Addendum No. 1
Northridge Elevated Storage Tank Painting and Rehabilitation Project
SAWS Job No. 10-0103
SAWS Solicitation No. B-11-035-DD

ADDENDUM NO. 1

August 19, 2011

- A. The purpose of this addendum is to issue revisions to the plans and specifications for the Northridge Elevated Storage Tank Painting and Rehabilitation Project (SAWS Job No. 10-0103; SAWS Solicitation No. B-11-035-DD).

SA
 NORTHTRIDGE EST
 PAINTING & REHAB. PROJECT
SITE IMPROVEMENT & DIMENSION PLAN

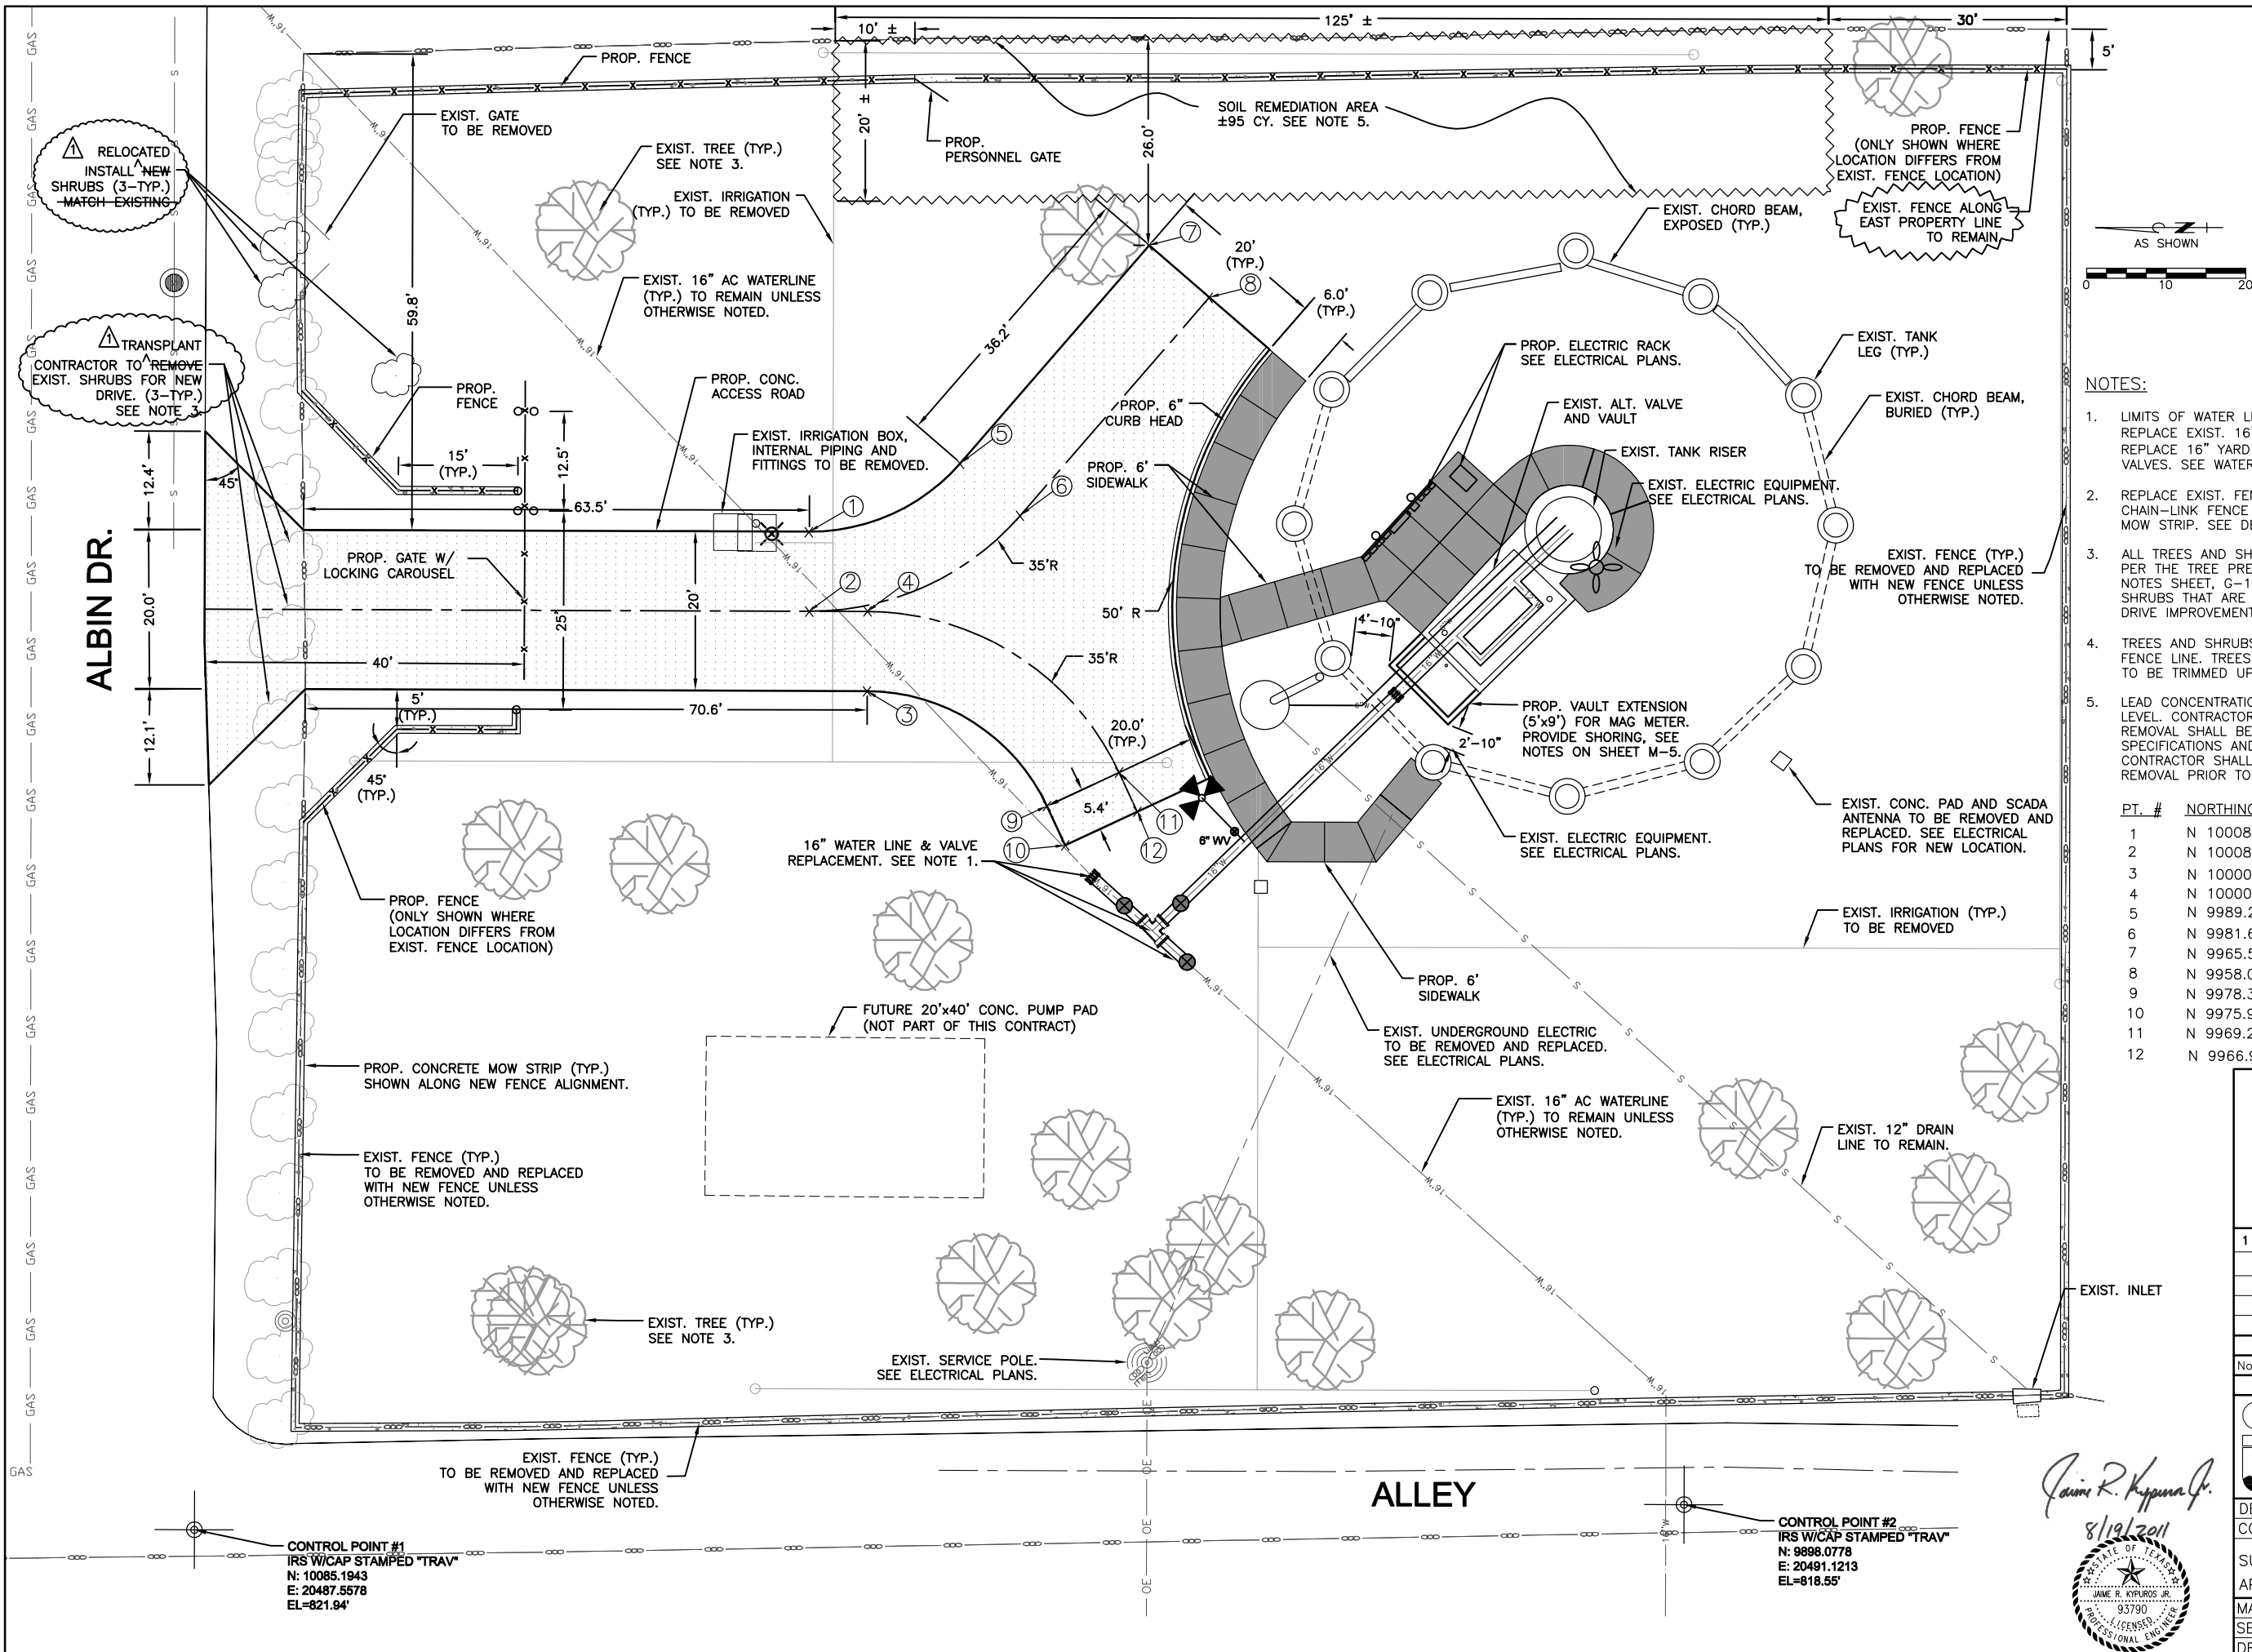
- A. Drawing C-2, SITE IMPROVEMENT & DIMESION PLAN
- i. Replace Sheet C-2 with new Sheet C-2 that is included with this Addendum No. 1. Changes are shown with revision clouds and include:
 - a. Shrubs on north fence line called for removal shall be transplanted as shown on plans. Proper procedures for transplanting shall be followed to ensure survivability of mature shrubs. A commercial tree spade or similar procedure shall be utilized for transplanting. Contractor shall stake transplanted shrubs utilizing commercial grade tree/shrub staking equipment specifically manufactured for the landscaping industry. Contractor is responsible for watering and overall establishment of the transplanted shrubs through the end of the project warranty period. Contractor shall plant new trees equal in type and size if the transplanted trees do not survive.

1	TRANSPLANT SHRUBS	JAS/JPC	JRK	08-2011
No.	Revision	Drawn	Approved	Date
